Contract Quantity Adjustment/Change Order

Department Transportation Date: 10/7/2013
 Project Name Kenney Fort Blvd. (Arterial A)
 City Project ID Number TX02ARTA Change Order/Quantity Adjustment No. 5

Project Name Kenney Fort Blvd. (Arterial A)

CHANGE PROPOSAL #012

LIGHT POLE
FOUNDATION DETAILS
KENNEY FORT BOULEVARD

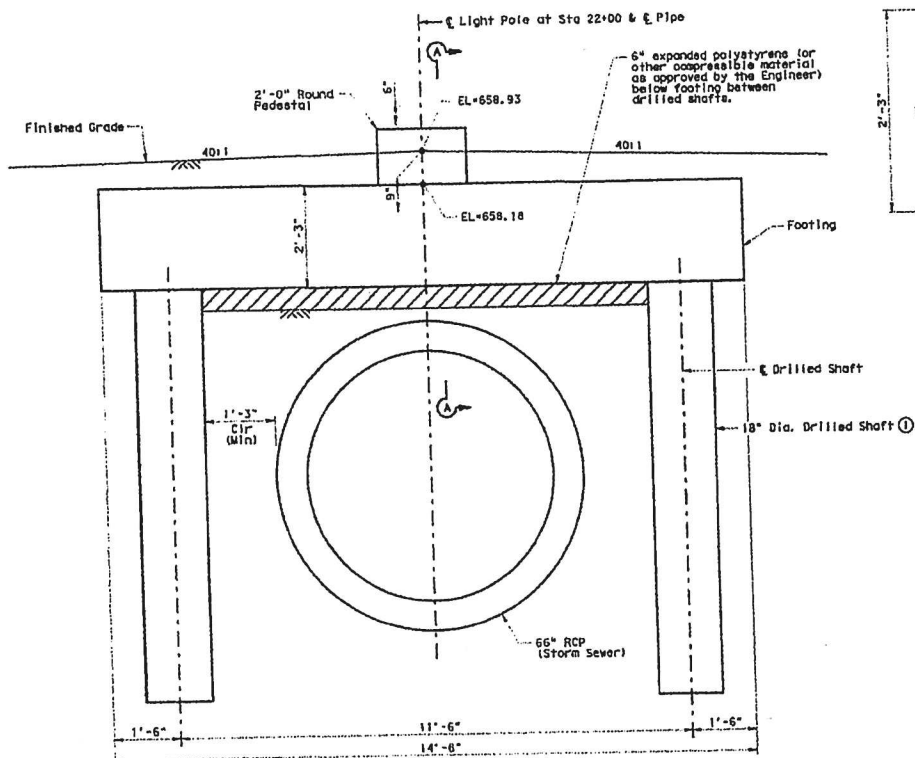
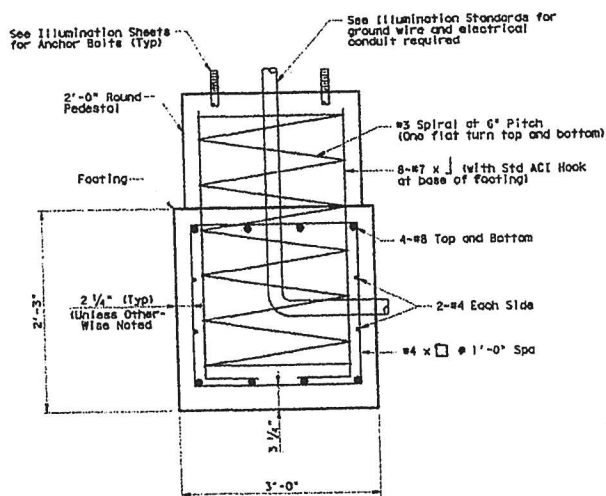
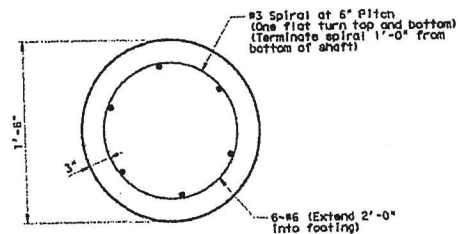
1	Rework signalization at Forest Creek intersection	1	LS	\$1,855.00	\$1,855.00
2	Revise light pole foundation to straddle 66" SS line	1	LS	\$2,650.00	\$2,650.00
					\$4,505.00

Bid Item	Item Number	Bid Item Description	Unit of Measure	Approx. Quantities	ESTIMATED COST	Amount
1		SPREAD FOOTING LIGHT POLE FOUNDATION SPECIAL	EA	1	\$2,650.00	\$2,650.00
Total Bid Amount						\$2,650.00

- 1) AS PER DRAWING DATED 7-1-13
- 2) VOLUME = $4.82 \times 1.10 = 5.30$ CY @ \$ 500.00 CY = \$ 2650.00

- ① 18" Dia. Drilled Shafts shall extend to 1'-0" below bottom of 66" RCP and shall have a minimum length of 8'-0".
